MIL-R-83536/19
AMENDMENT 1
15 December 1995

MILITARY SPECIFICATION SHEET

RELAYS, ELECTROMAGNETIC, ESTABLISHED RELIABILITY, 4PDT, LOW LEVEL TO 10 AMPERES, MAGNETIC LATCH, HERMETICALLY SEALED, ALL WELDED, TRANSIENT SUPPRESSED DC COIL

This amendment forms a part of MIL-R-83536/19, dated 27 March 1992, and is approved for use by all Departments and Agencies of the Department of Defense

CIRCUIT DIAGRAM (TRACK MOUNT)
(ALTERNATE INTERNAL
DIODE CONFIGURATION)

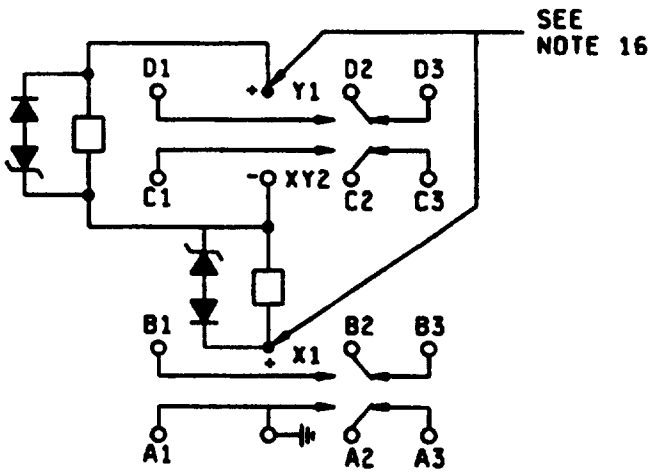
FIGURE 2, add the following circuit diagram

SEE NOTES 4, 5, AND 6
